FIELD INSPECTION REPORT

Project Name:	Mountain Valley Pipeline	Inspector:	Matthew Grant
Inspection Date:	Wednesday, October 20, 2021	Project Contact:	Brian Clauto
Spread H: Roanoke	AR 278 ATWS1326 St12543+75-12518	Weather:	Dry

Figure 1: St 12540 ROW requires additional stabilization

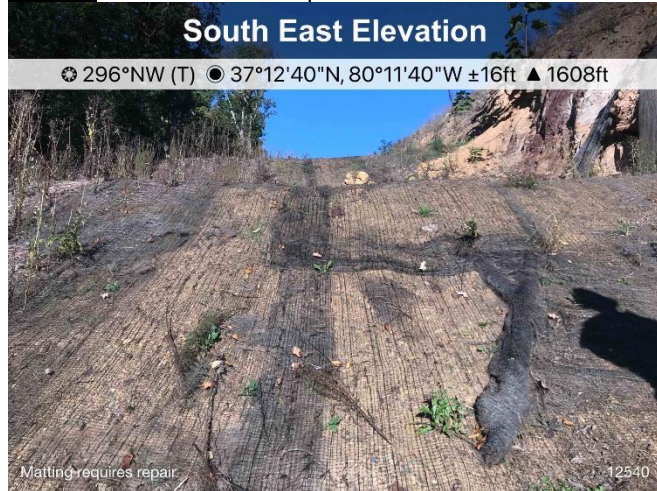
- Sta 12543+75- 12520 ROW lacks adequate stabilization / erosion control matting deteriorated
- Sta 12510- 12518 ROW lacks adequate stabilization / erosion control matting deteriorated.

Recommended Corrective Action: Maintain and install all controls per the approved PSS&S.

Figure 3: St 12522 CFS requires maintenance

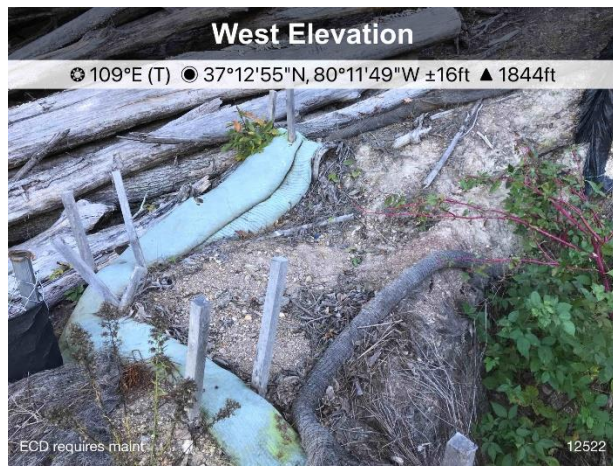
- Sta 12530- Trash not contained on ROW
- Sta 12523- Trash not contained on ROW
- Sta 12522 CFS end treatment over 50% full of sediment
